ADDENDUM

No. 04 **Date:** 9/18/2024
Project No. 0020711.01 **Attention:** Leonard D'Souza
Project Name: Princess Margaret Cancer Centre
Stem Cell Transplant 2, MHC, MHDU, DSC
Address: University Health Network
610 University Avenue
Toronto ON

The following architectural questions have been received by the Bidder(s) and the following answers are being provided to all Bidder(s).

4 SECTION 3 - BLDG 610
1:100

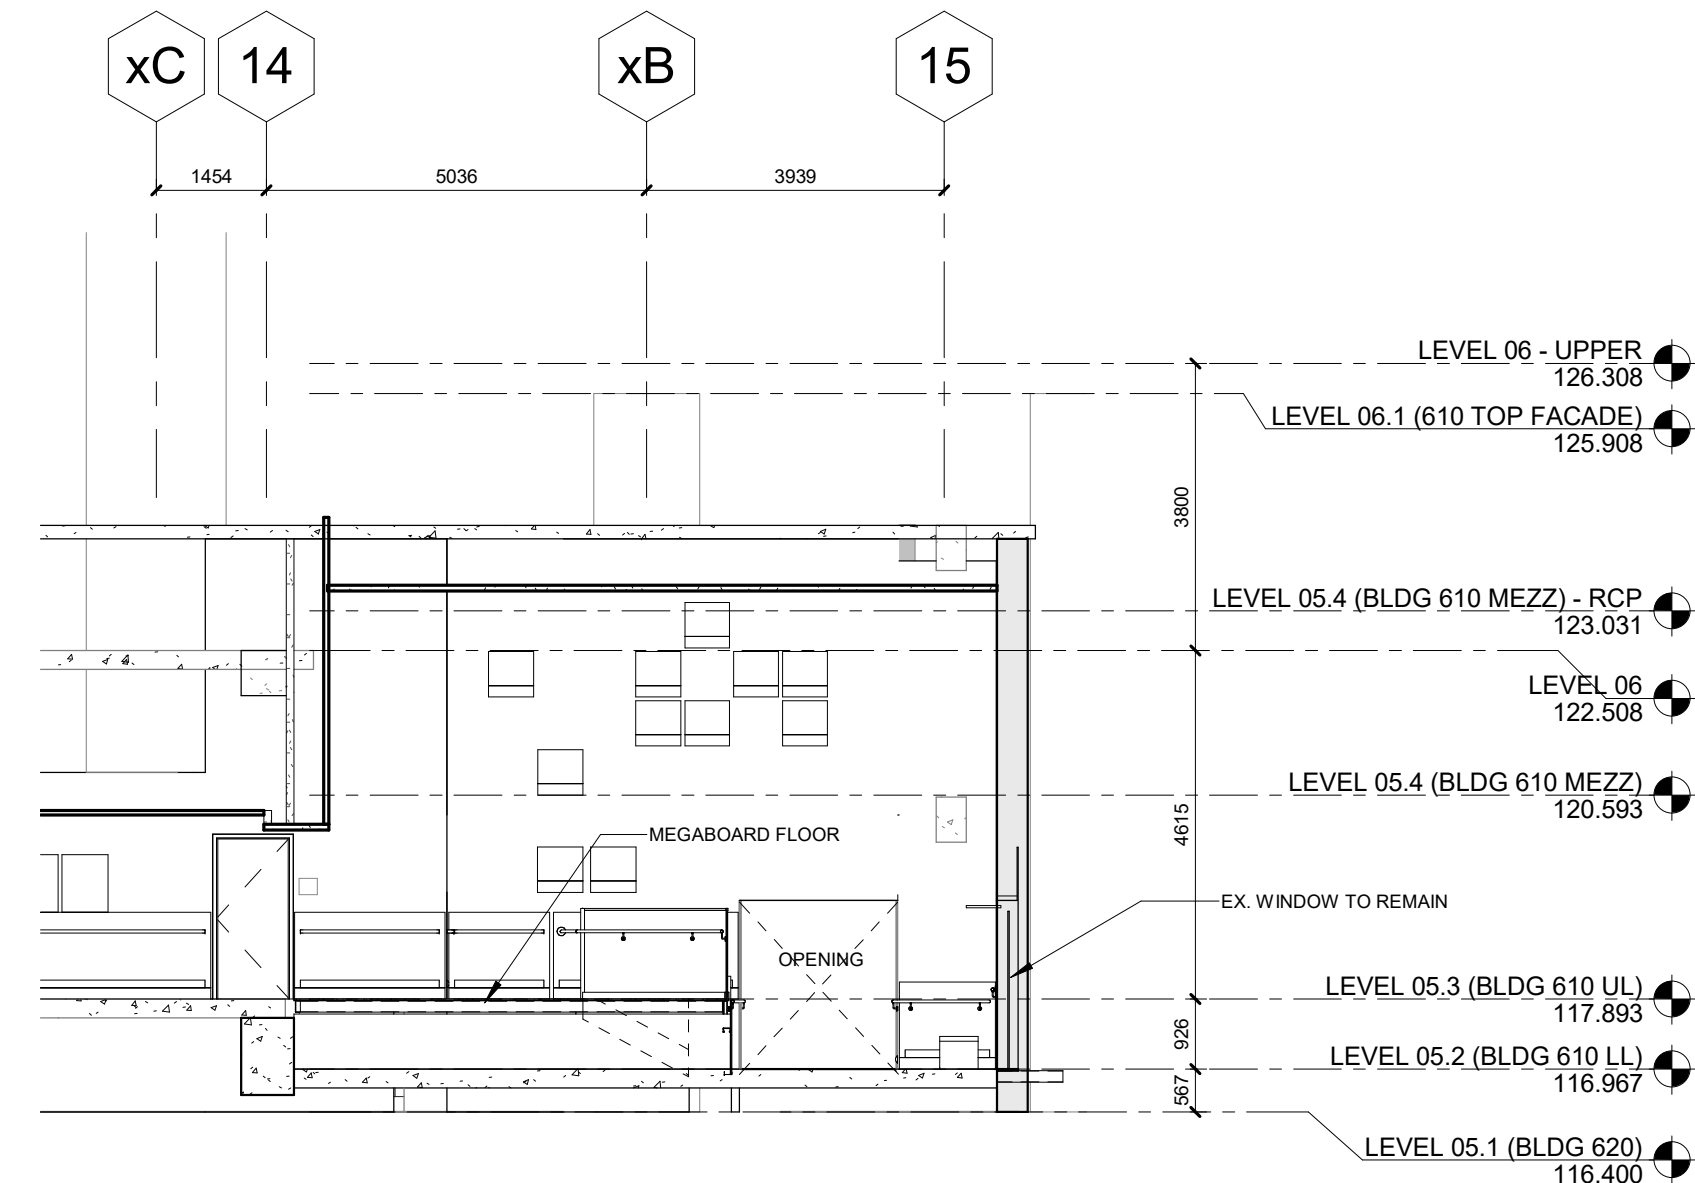
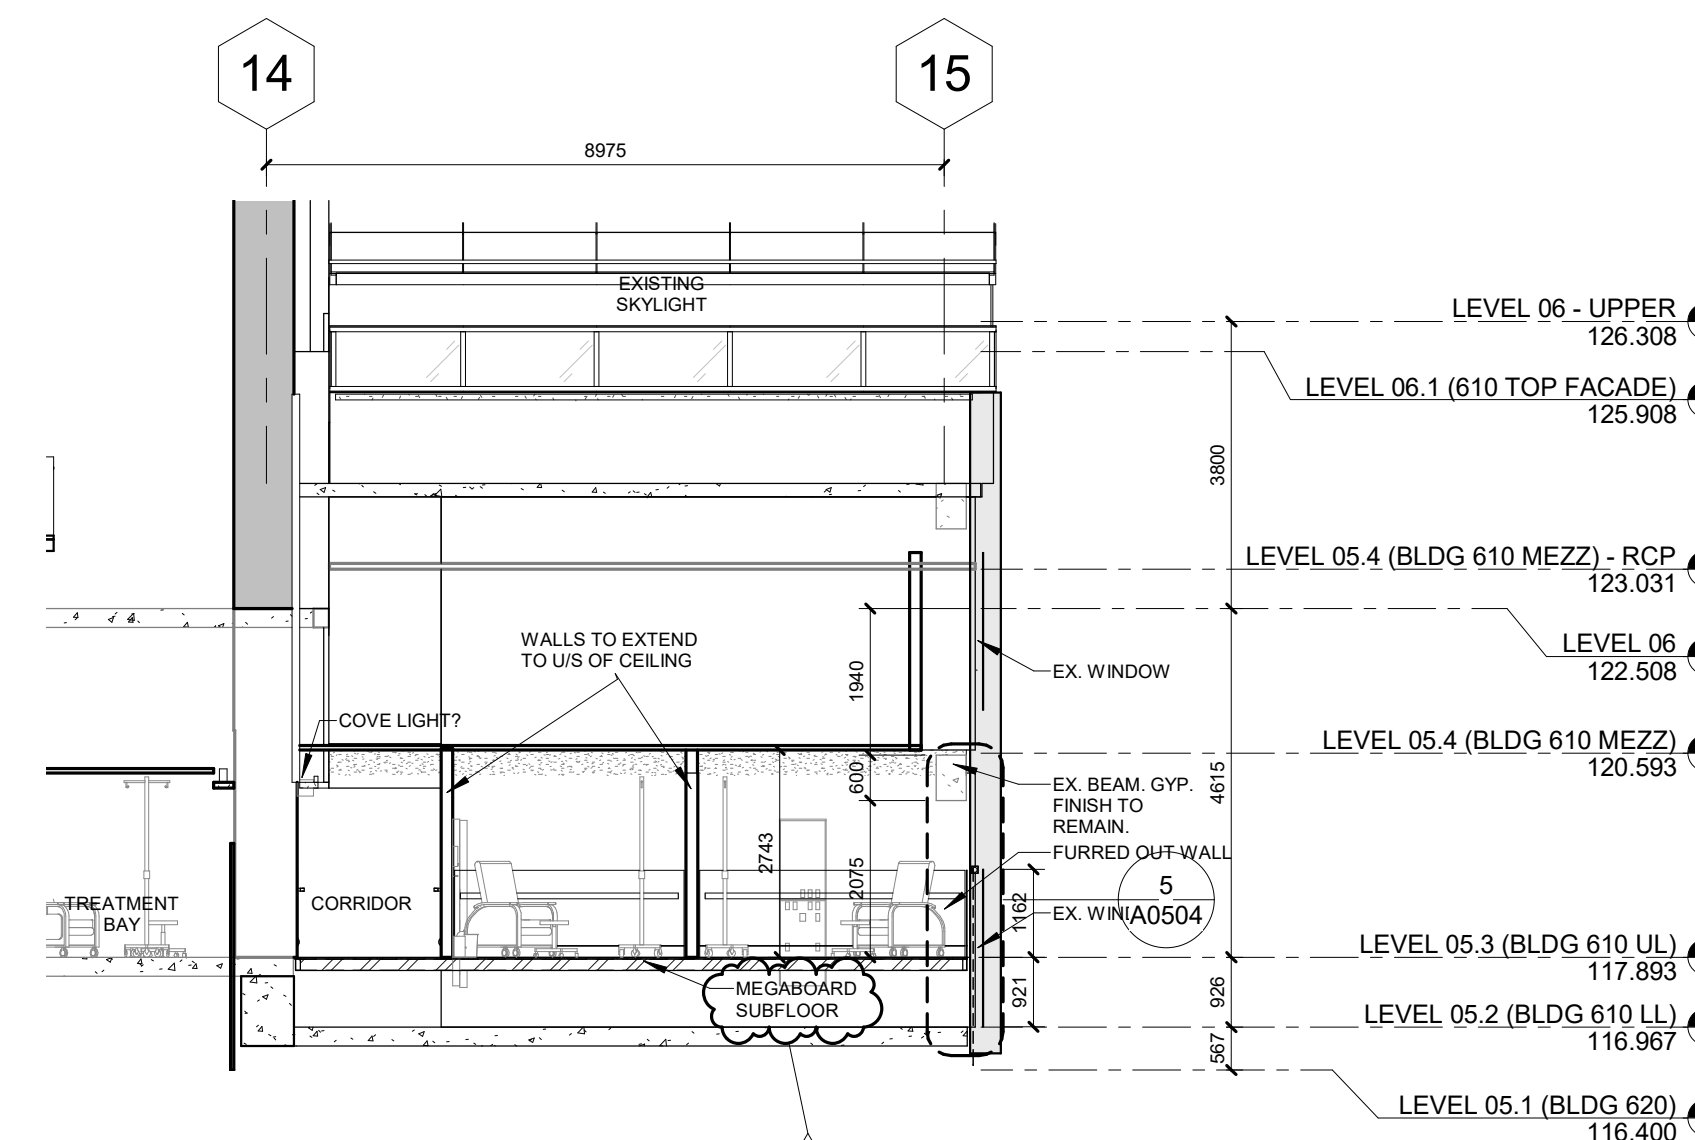
48. (414) (Dwg A0504, S0002) Dwg A0504 detail 1 & 5 show Steel Channel (by Misc. Metal trade) attached to Structural stud framing (by drywall trade). The structural dwg S0002 details A, B, C & D do not show any Misc. Metal support. Please confirm the provided details are correct and if steel channel are required, please provide the size and detail.

Response: Glass guardrails at floor and ramp edges are supported HSS10x2x1/4 (51x254mm) as shown in the detail 2/A0504 and the HSS tube locations have been

specified in the detail 1/A0501. Engineered shop drawings submittal to include glass guard rails.

13 TYPICAL EXPANSION JOINT AT COLUMN
1: 20

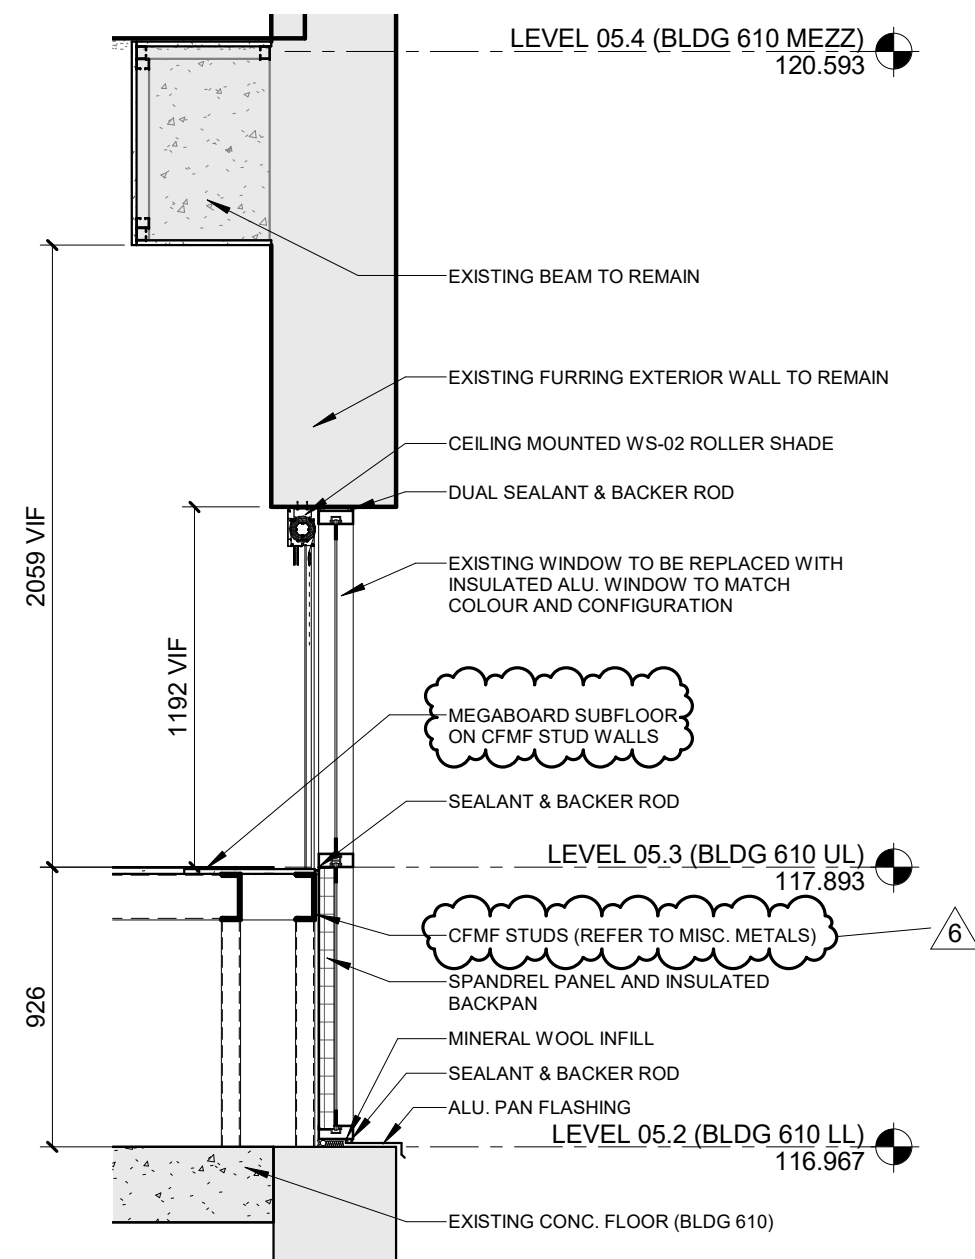
18. (254) Drawing A0504 shows two sections 13 and 14, mentioning Typical expansion joint on columns and at doors.

1 SPANDREL WINDOW DETAIL
1: 25

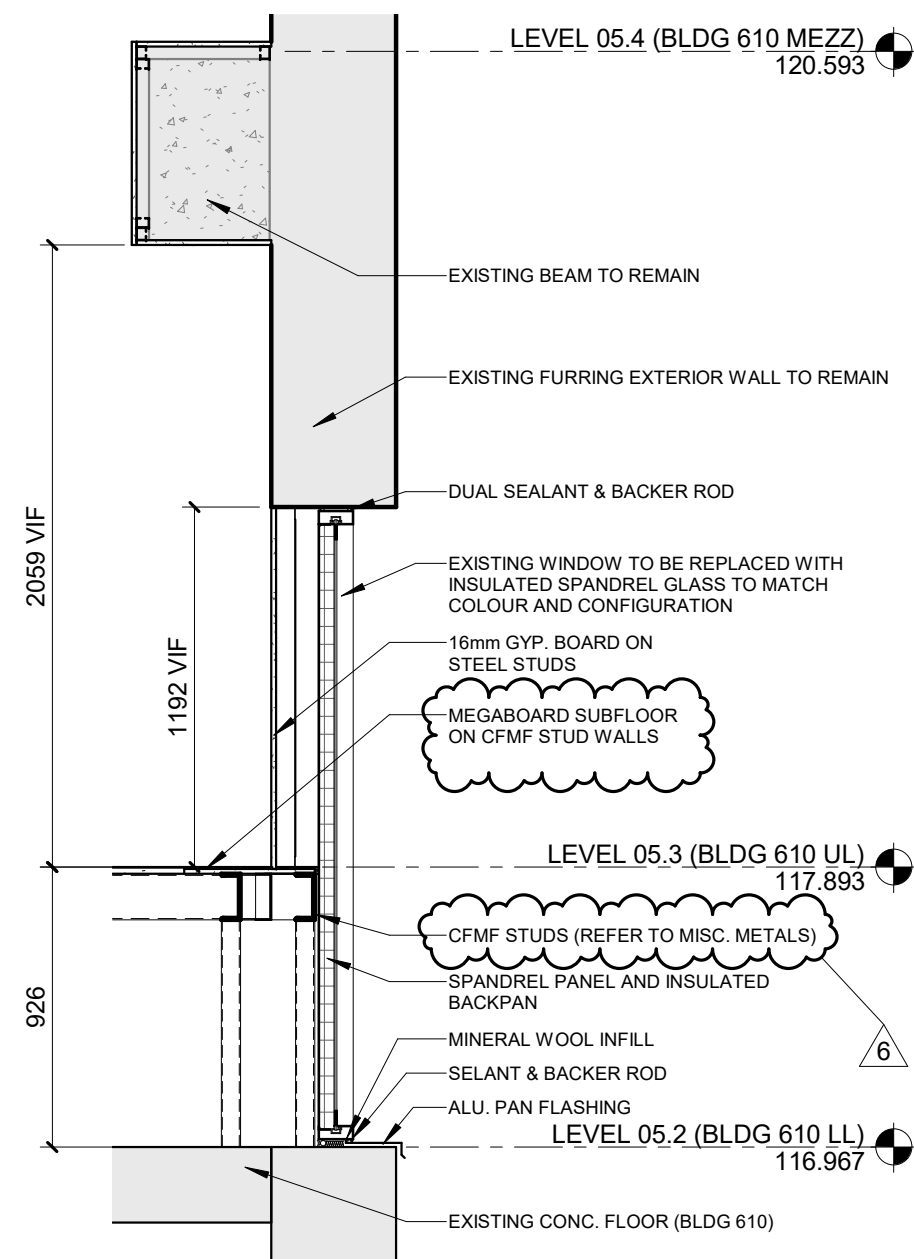
5. (211) Please clarify what are colour and configuration of existing windows to much as directed on det. 5/A0504 and det.1/A0504

47. (413) (Dwg A0504, A0501, S0002,) Dwg A0504 detail 1 & 5 show Steel Channel (by Misc. Metal trade) sitting on Structural stud support (by drywall trade) to support Mega board Sub floor. The structural dwg S0002 details A, B, C & D do not show any Misc. Metal support. Please confirm the provided detail is correct. Ramps & deck framing plan, detail 1 on dwg A0501 shows, rows of steel stud wall attached together. If the Miscellaneous metal framing required above the stud wall, please provide a detailed layout and the steel member size.

Response: Megaboard floor is supported by CFMF studs. Details 1&5/A0504 have been updated accordingly.

D0102A

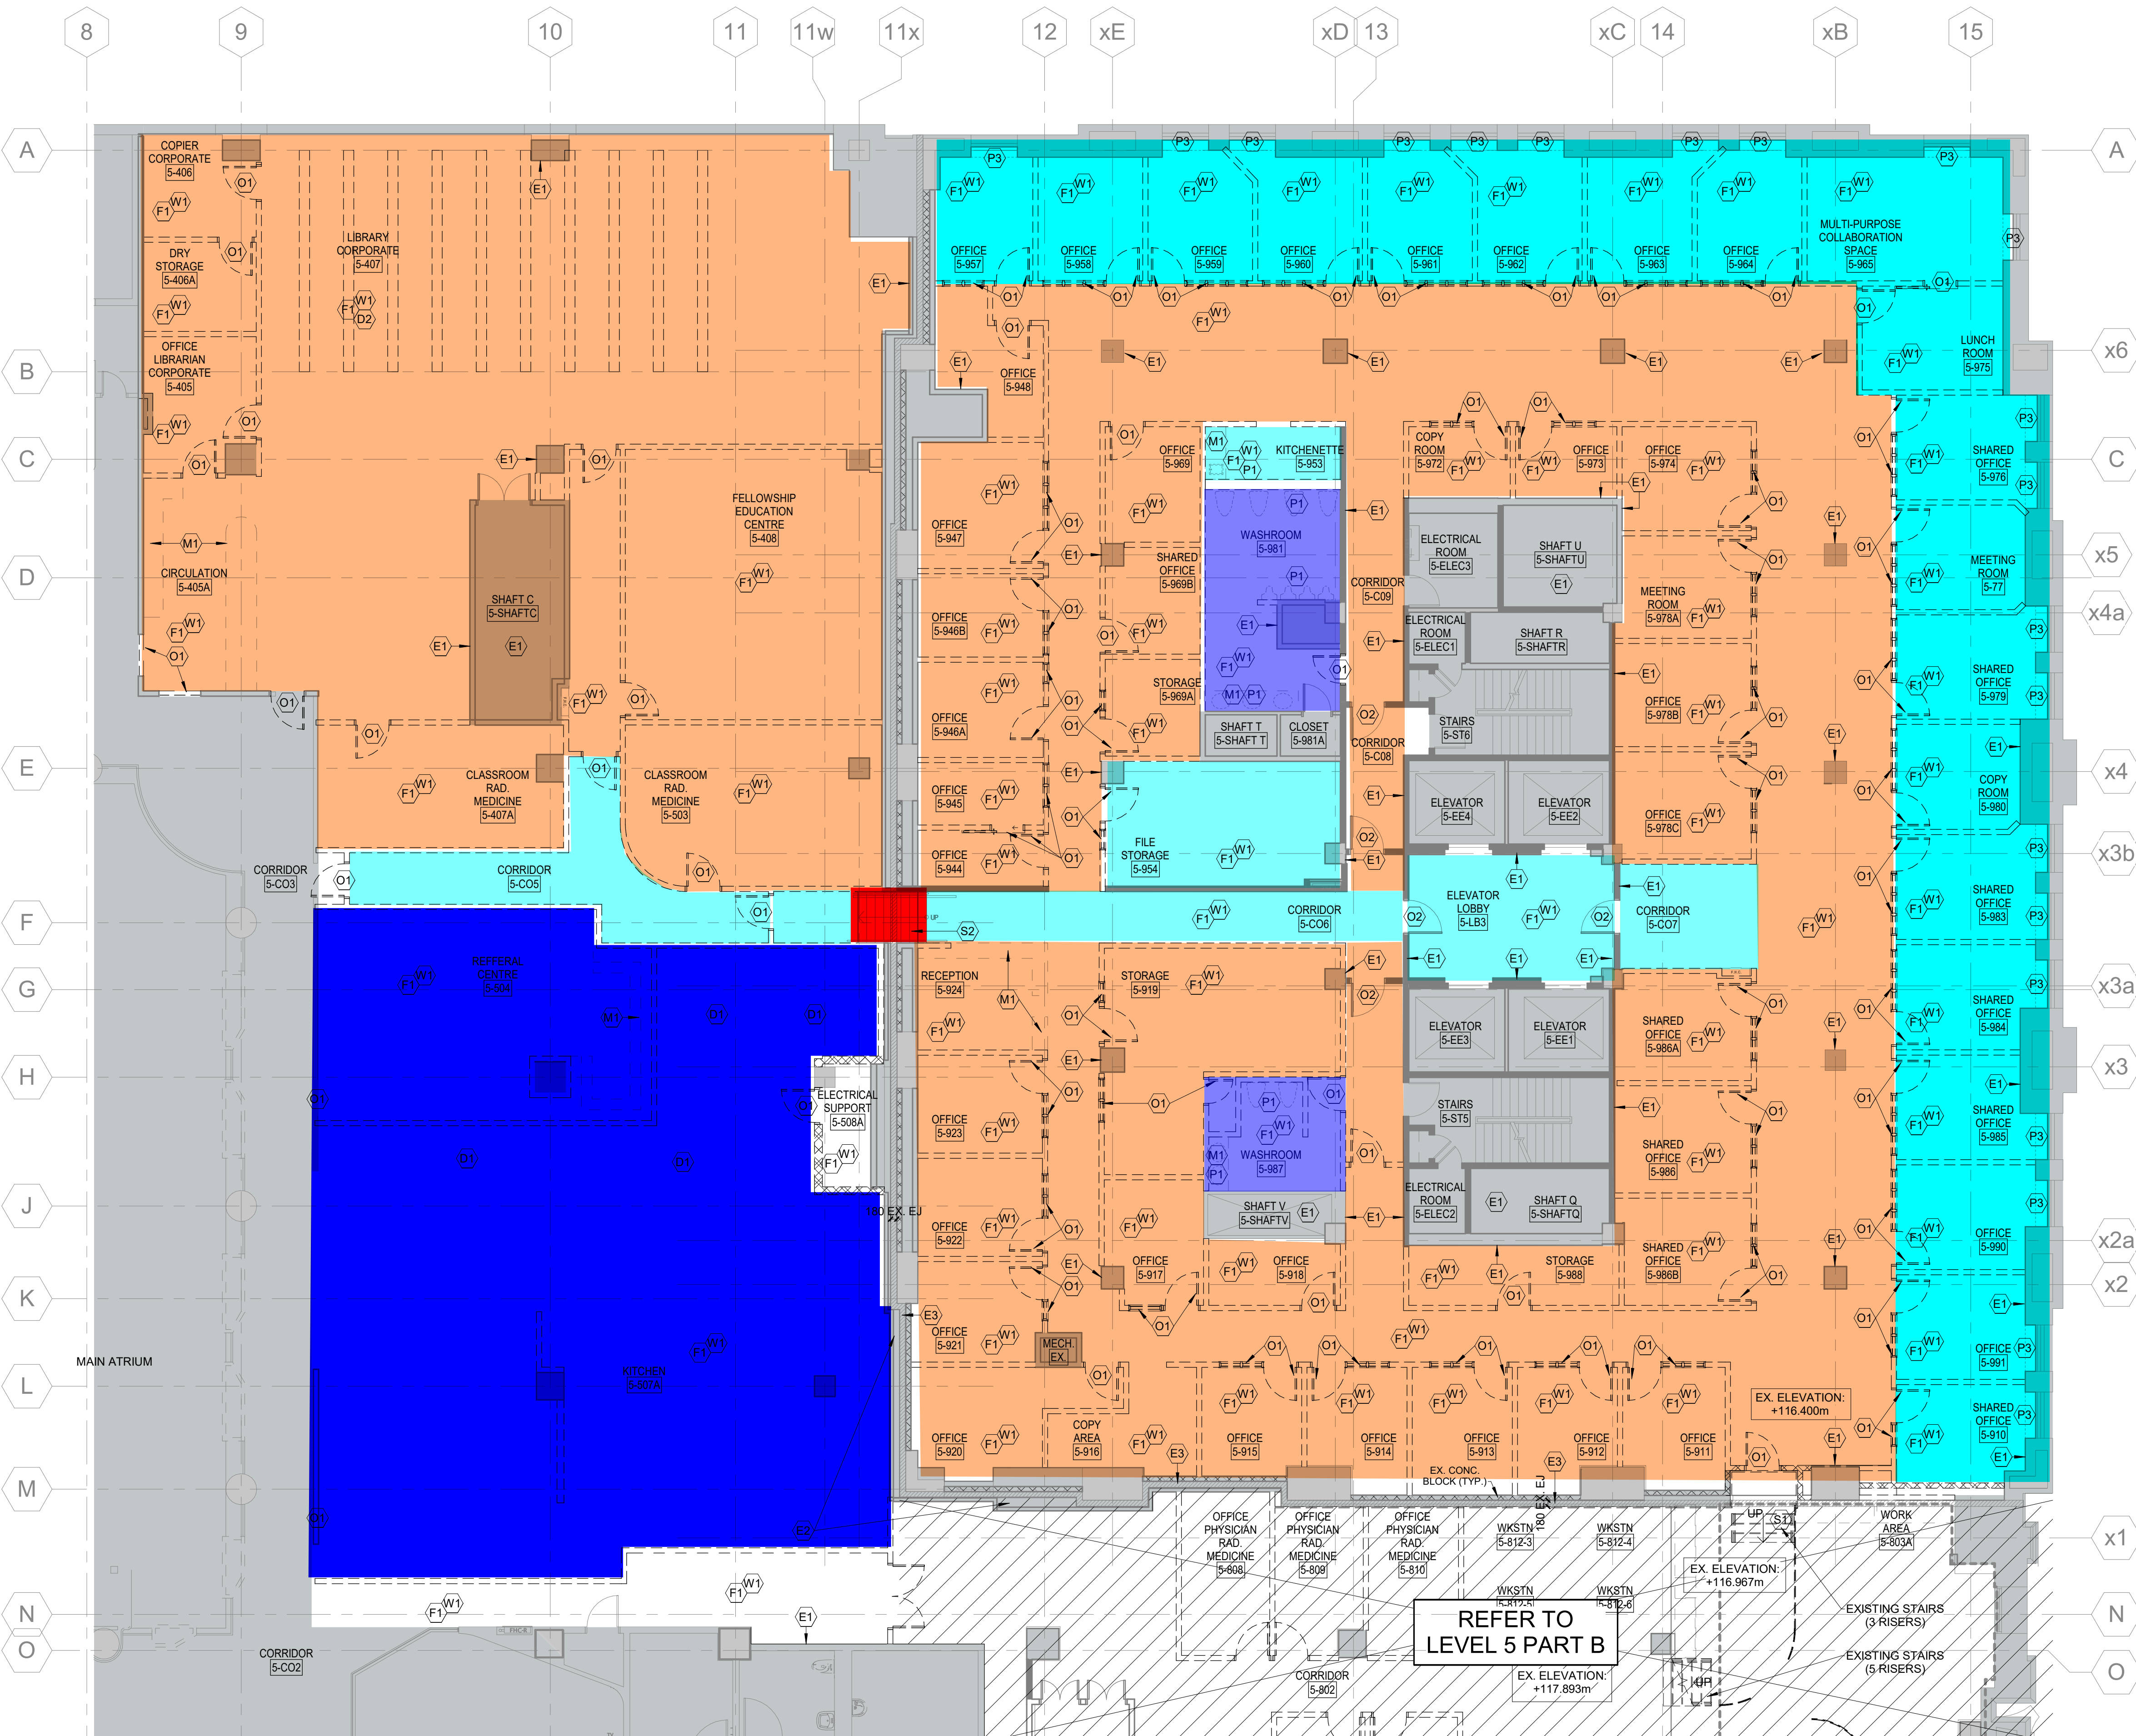
44. (410) (Dwg D0102A, D0105B, D0105B & D0110A) As per W1, Remove and dispose existing partition walls, Is it drywall/block wall? If it's a mix? Please Indicate on dwg or specify the existing wall type clearly."

45. (411) (Dwg D0102A, D0105B, D0105B & D0110A) As per F1, Remove and dispose existing flooring and base. Is it tile, terrazzo? . Please Indicate on dwg or specify the existing wall type clearly.
